COVER SHEET  
CIVIL PLANS

240 15TH STREET SE  
PUYALLUP, WA 98372

**FORTRESS - PUYALLUP**

# CONSTRUCTION DETAILS

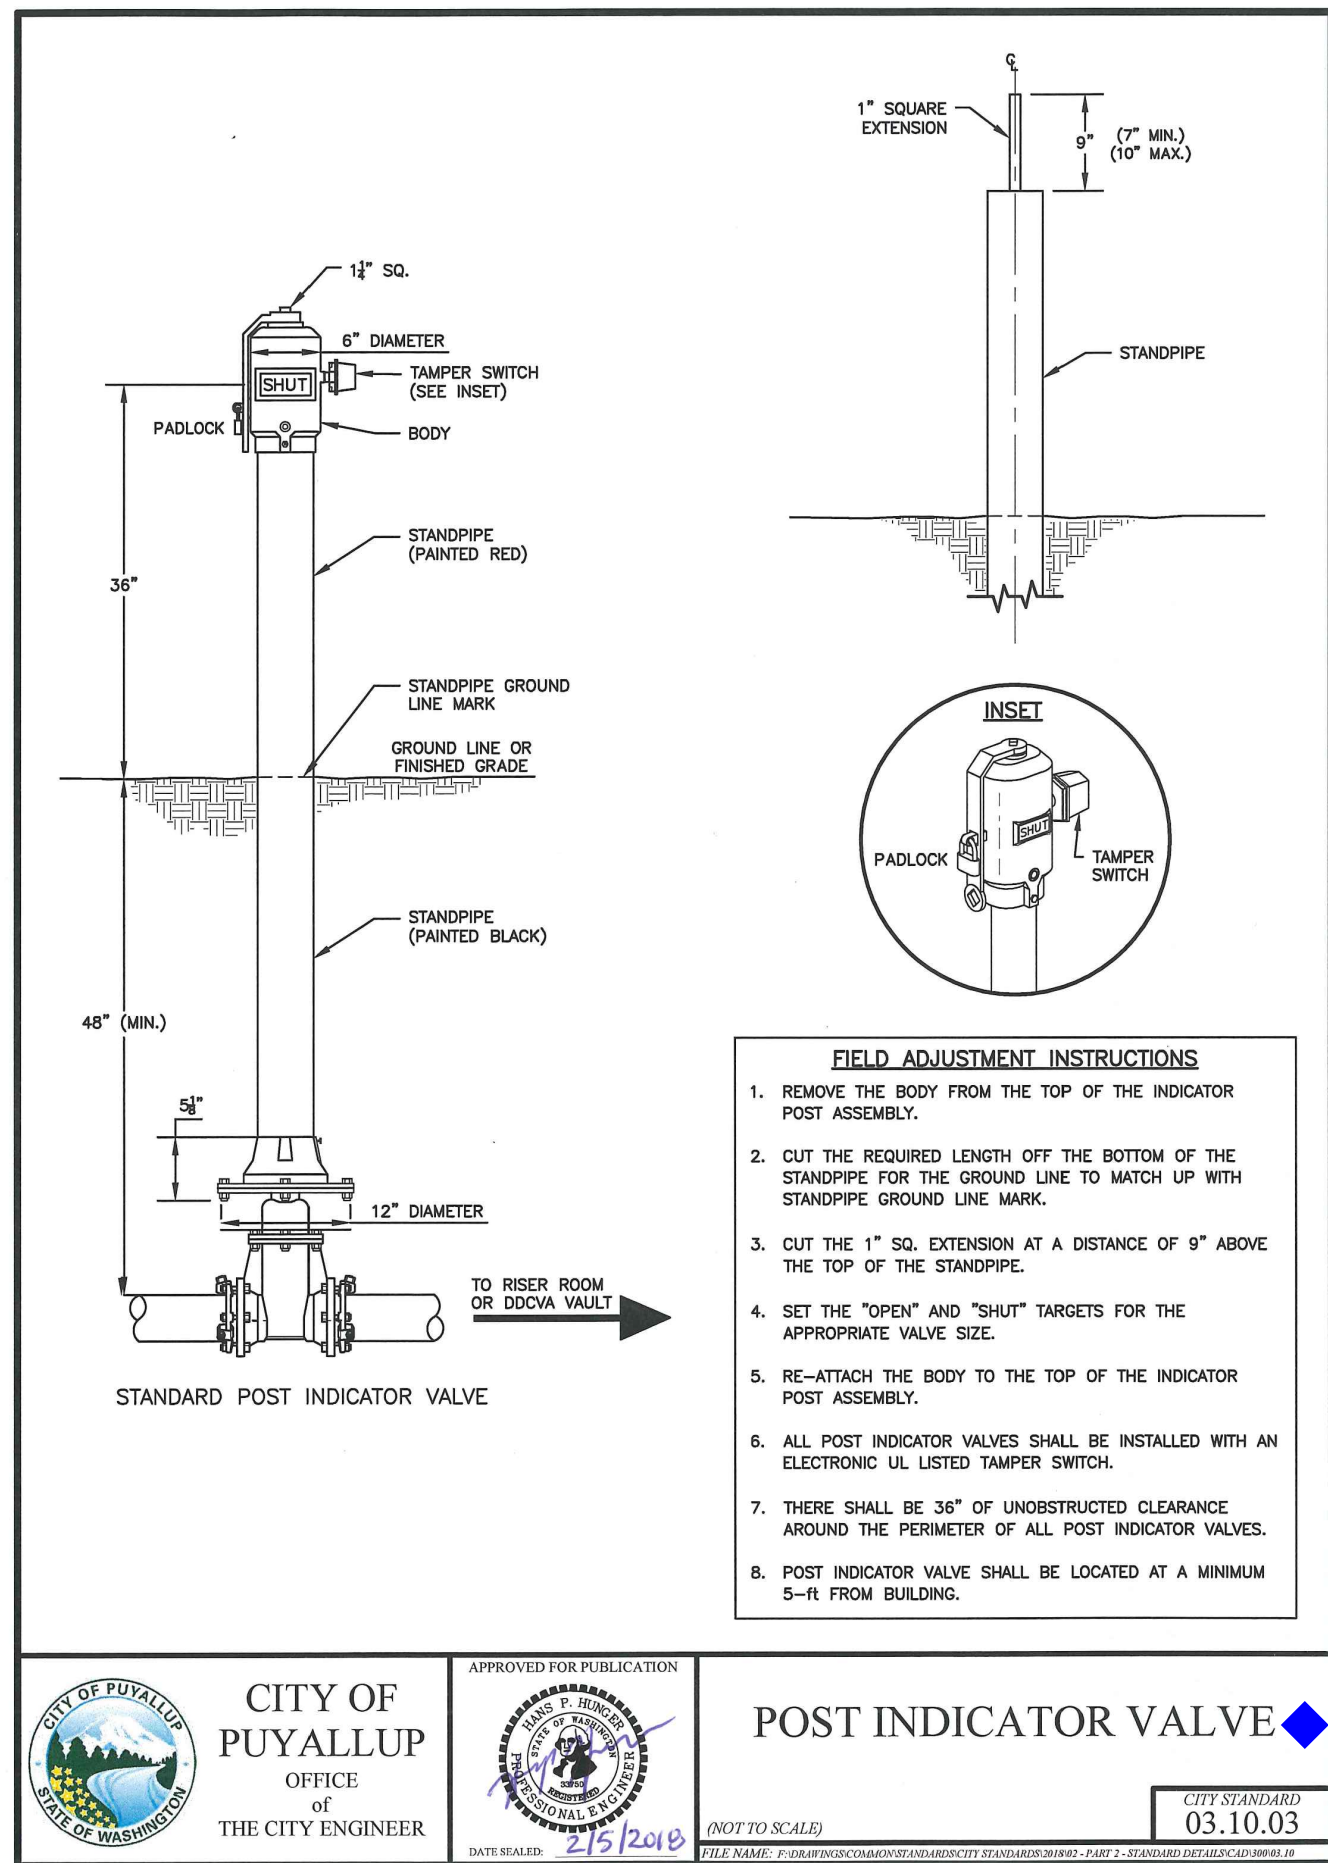
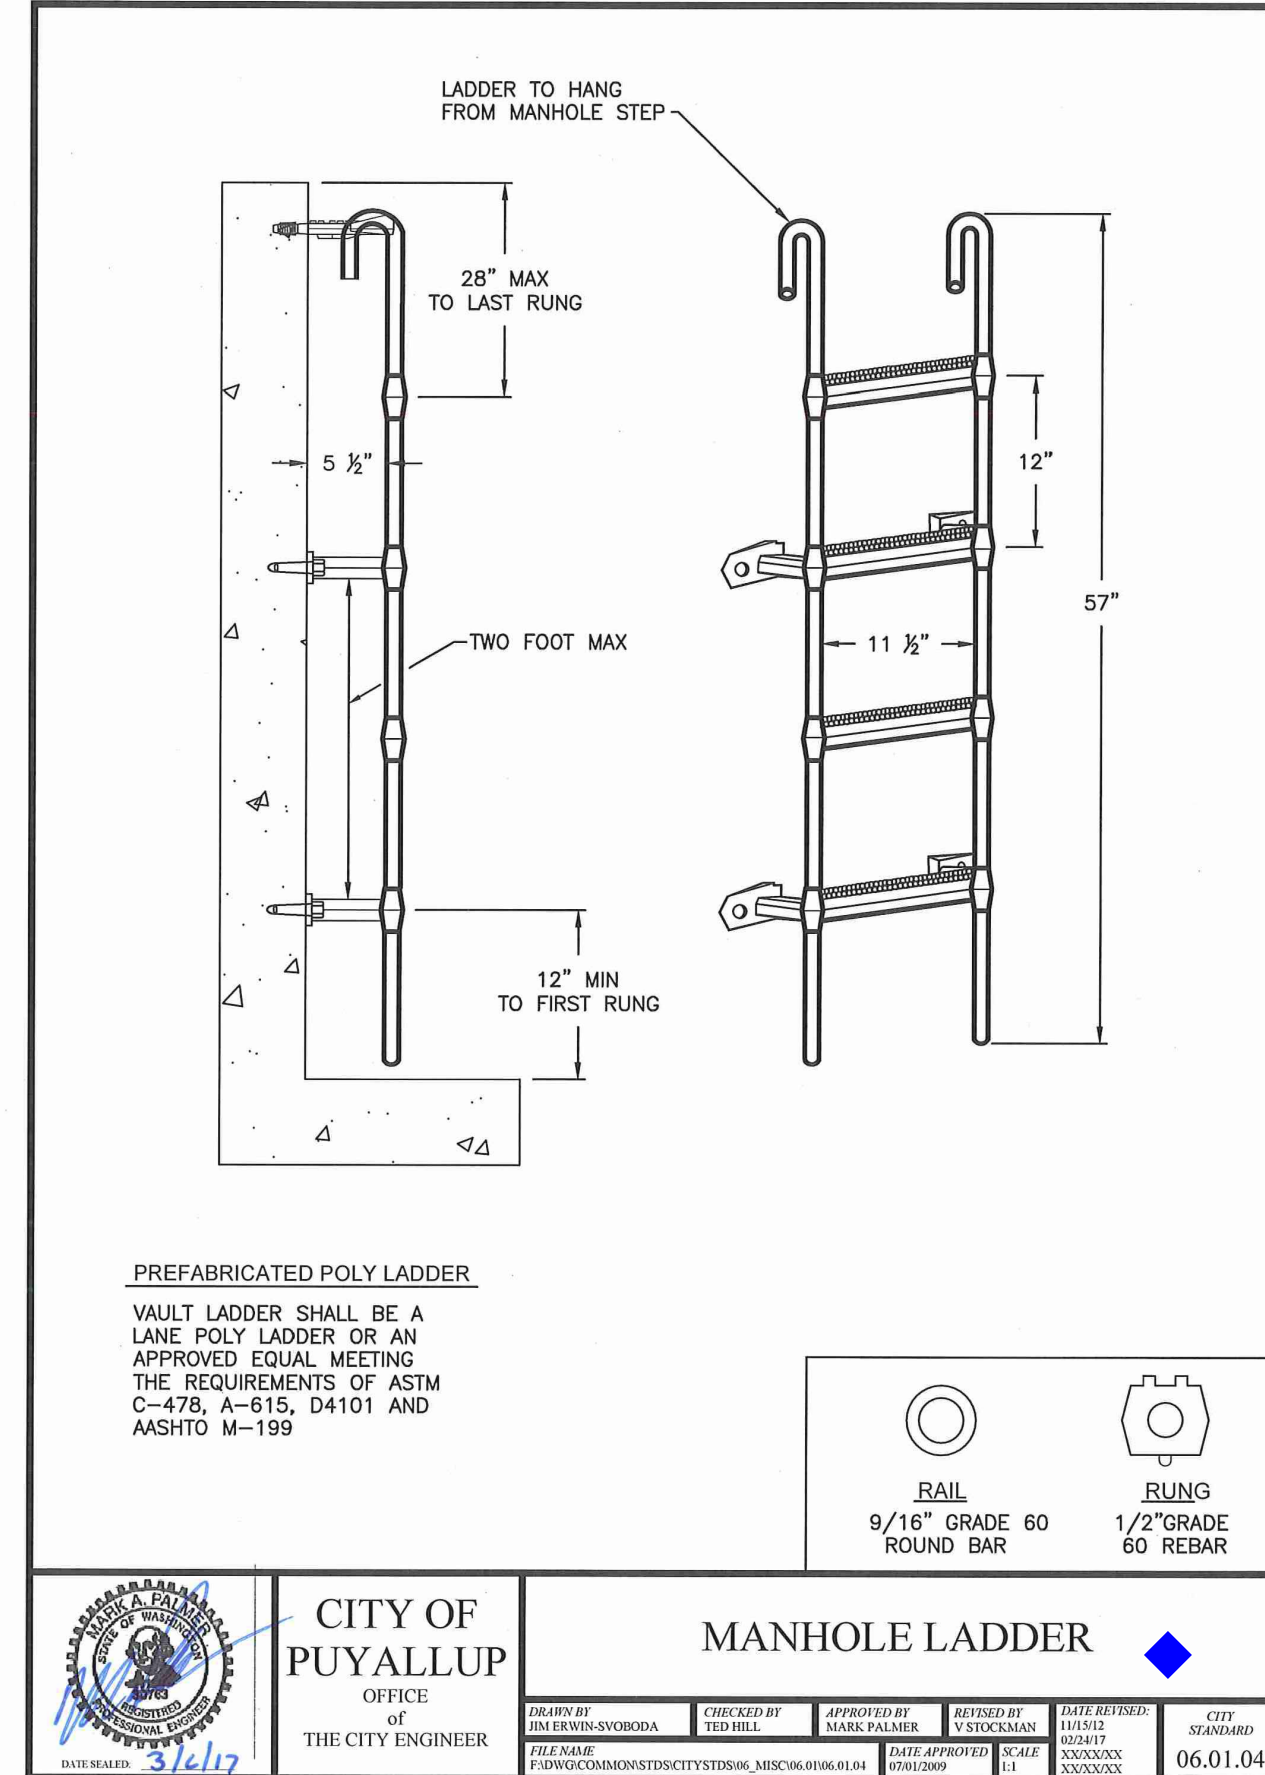
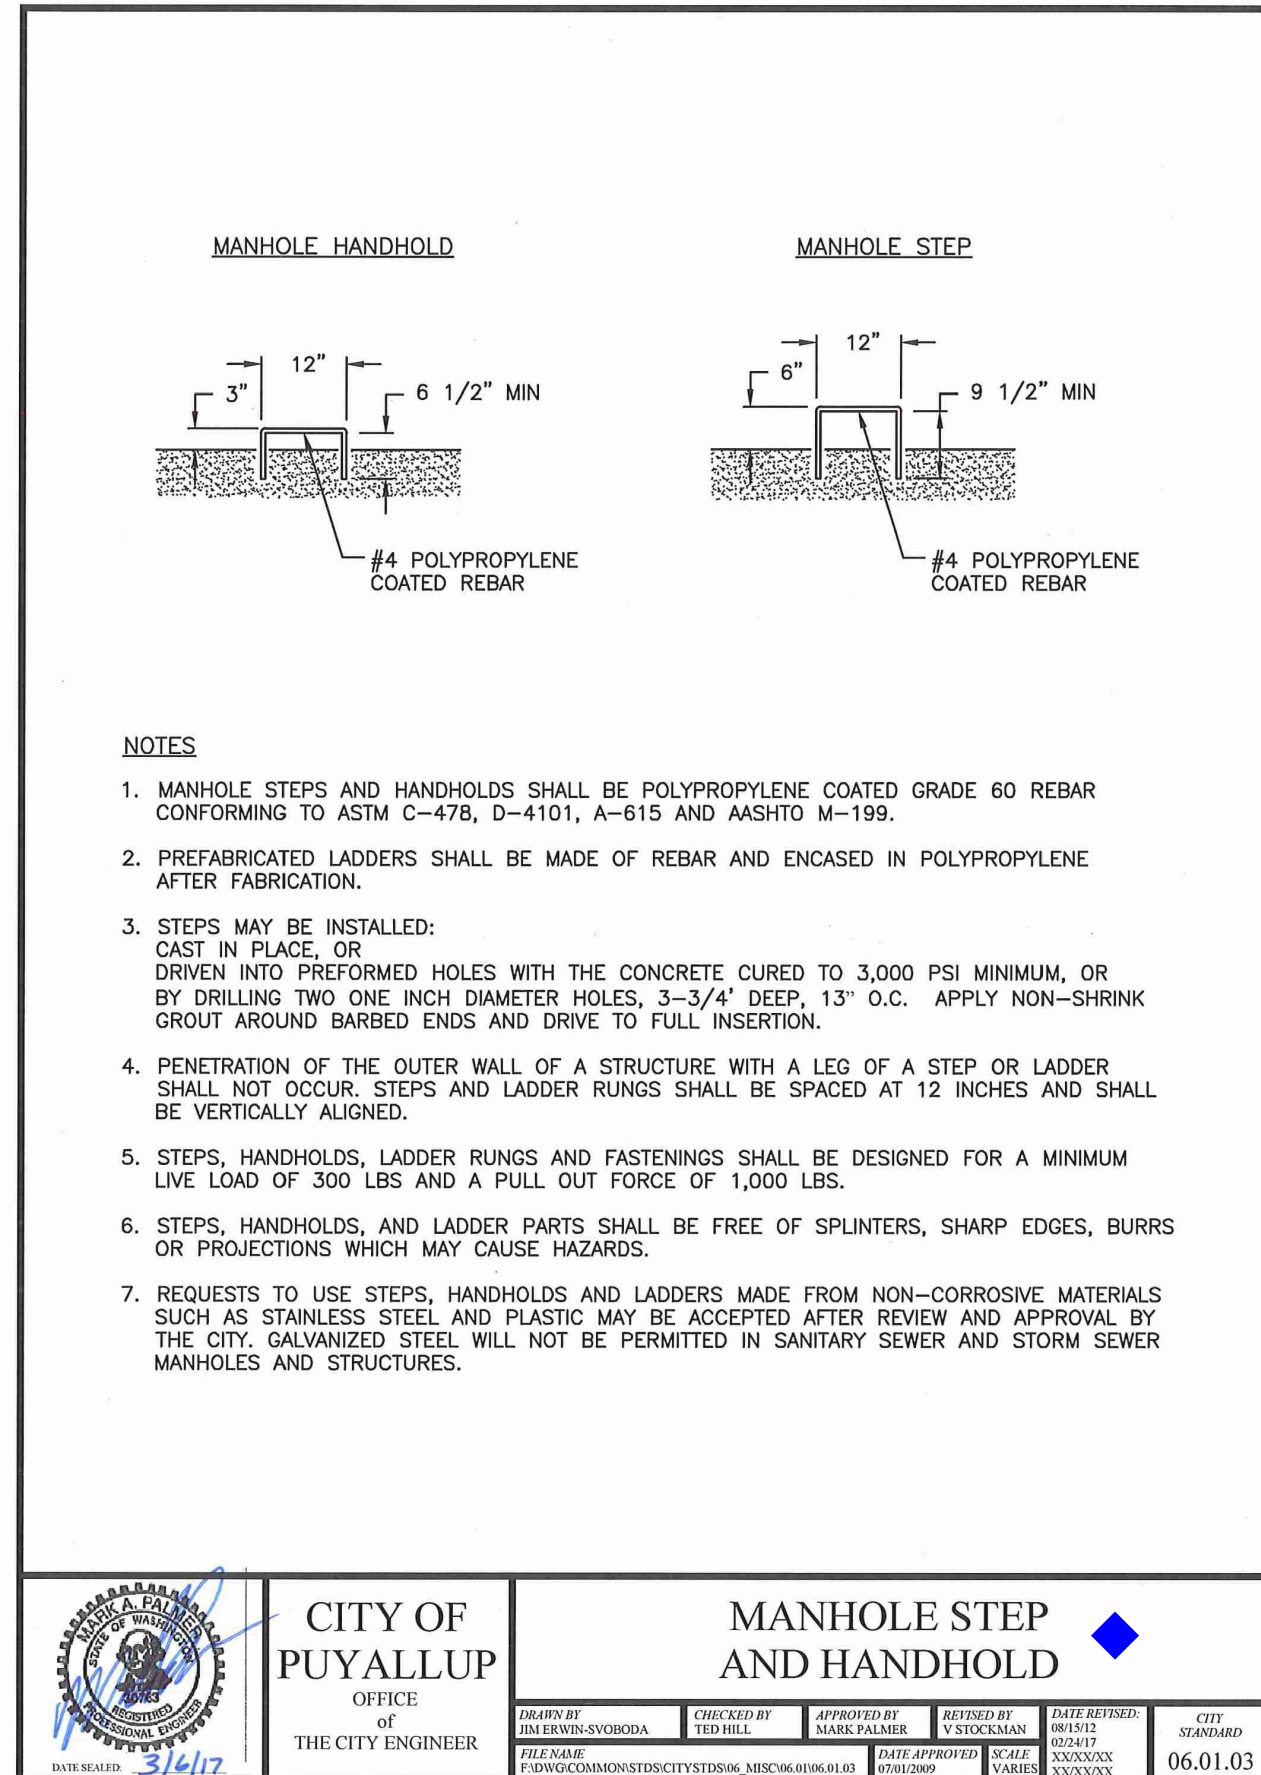
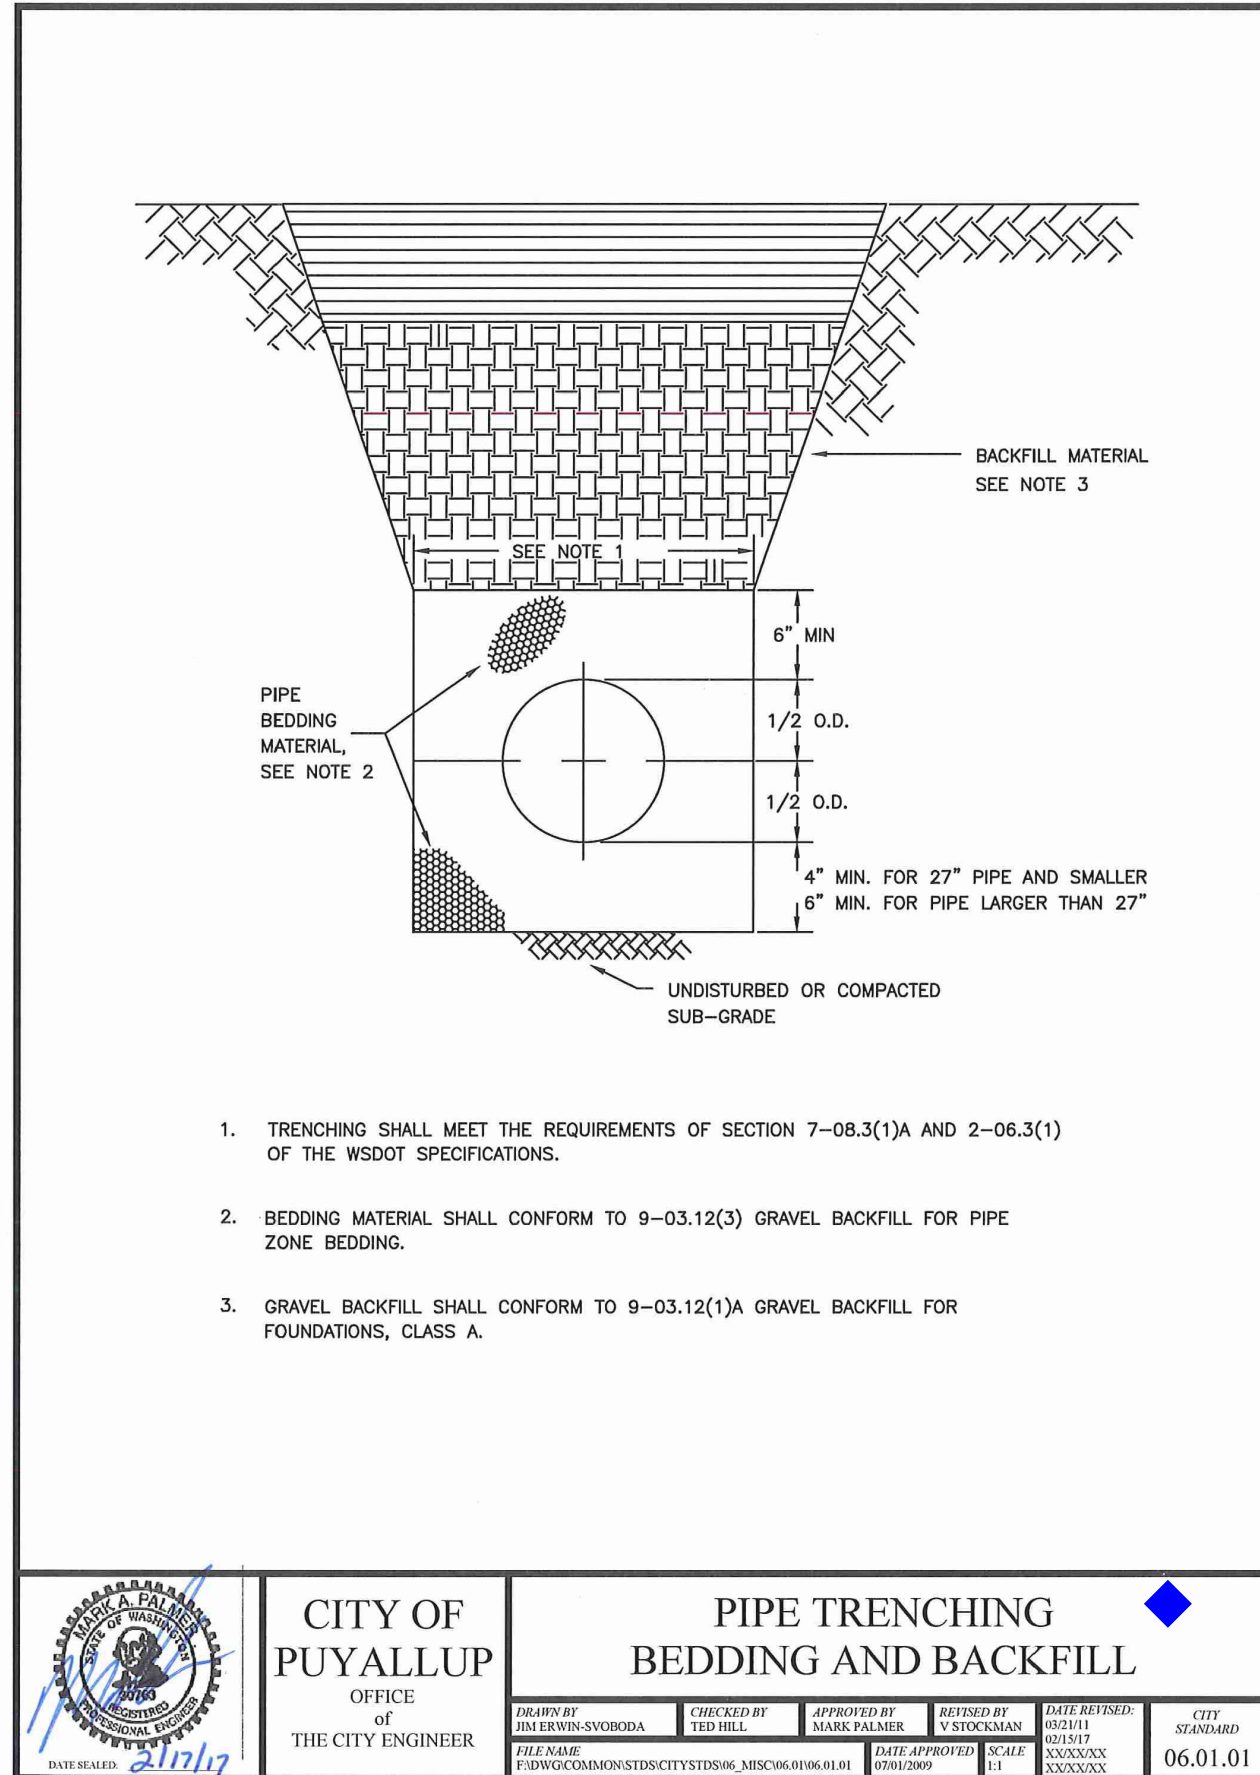
Civil Sheet C22: This water standard detail should be moved with the other water details on Sheet C24.
